ADDENDUM NO. 1

Date:	July 8, 2009
To:	Contractors
From:	Brian Bales– Project Manager
Reference:	Electrical Improvements – Machine Shop Snow College South – Richfield, Utah DFCM Project No. 08253710
Subject:	**Addendum No. 1**

Project: Snow College Richfield, Washburn Building
Machine Shop Electrical Remodel, Project # 08253710

Electrical Addendum #1

ONE-LINE DIAGRAM, REVISED 4-30-09

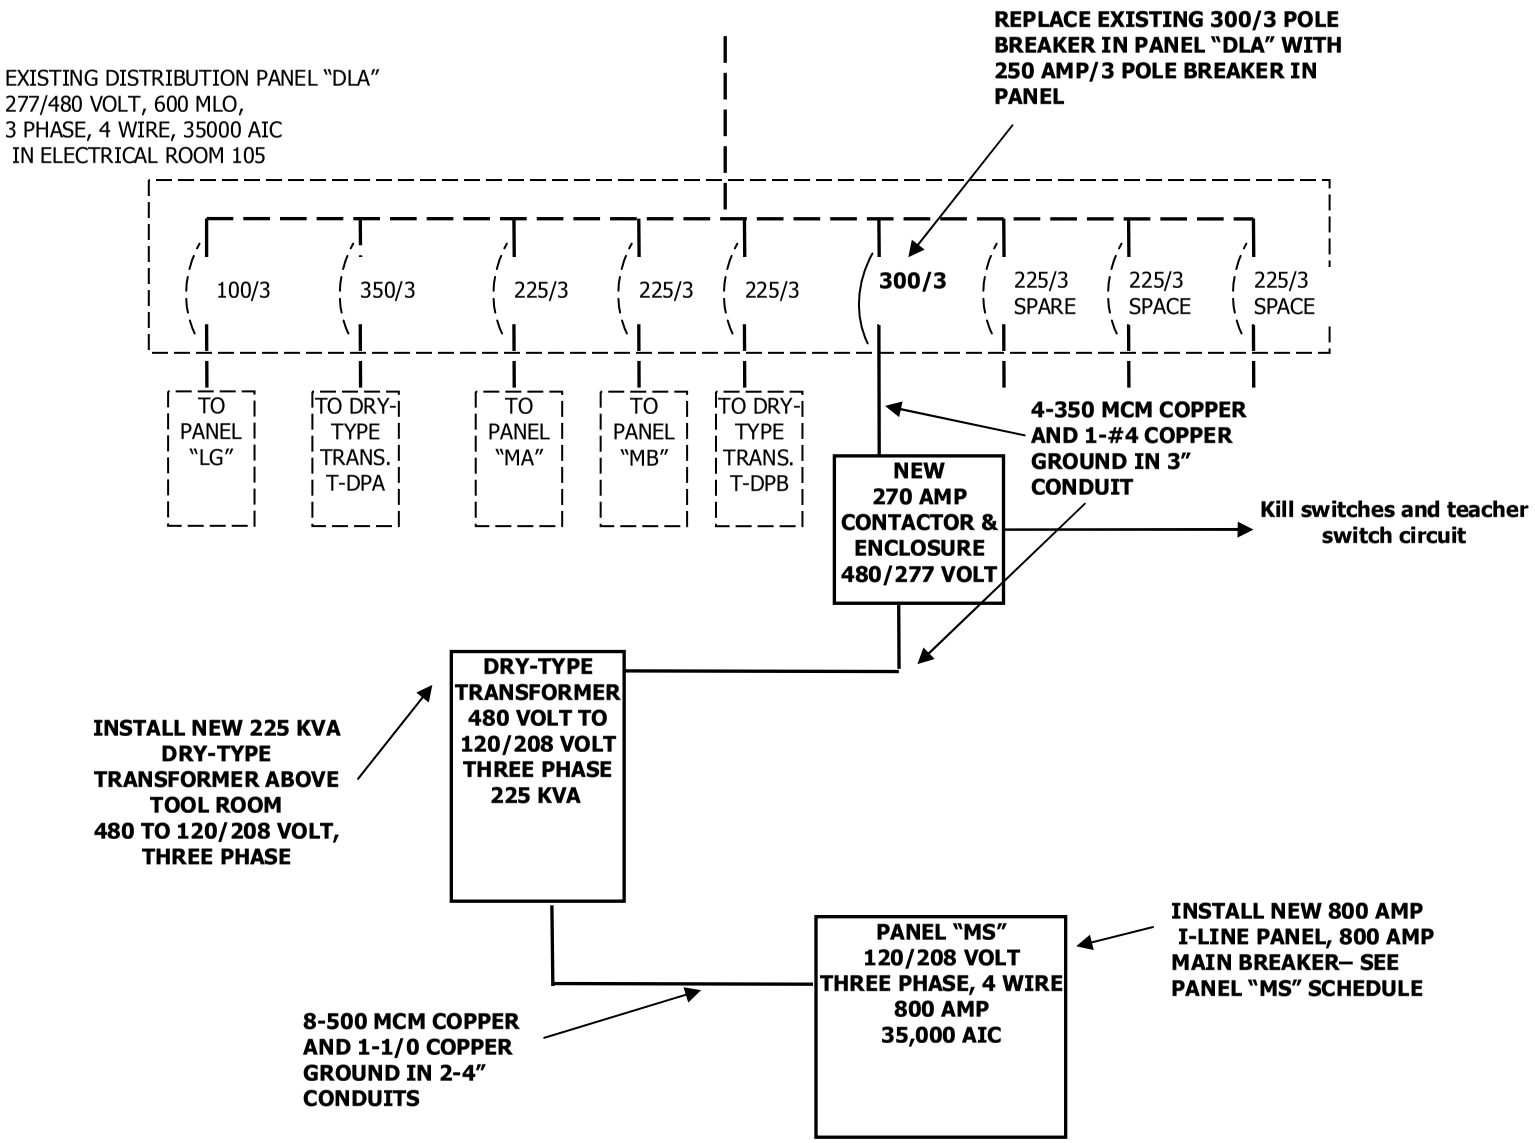
On sheet E04, One-Line Diagram, change the following:

1. In existing panel "DLA" where is it shown to replace existing 225 /3 pole breaker with 250 Amp/3 pole breaker change it read - "Replace existing 225 /3 pole breaker with 300 Amp/3 pole breaker in panel."
2. Conductors shown from new breaker in Panel "DLA" to new 270 Amp Contactor & Enclosure and to Dry-Type Transformer as 4-250 MCM Copper and 1-#4 copper ground in 3" conduit shall be changed to 4-350 MCM copper and 1-#4 copper ground in 3" conduit.

See attach one-line diagram, revised 4-30-09.
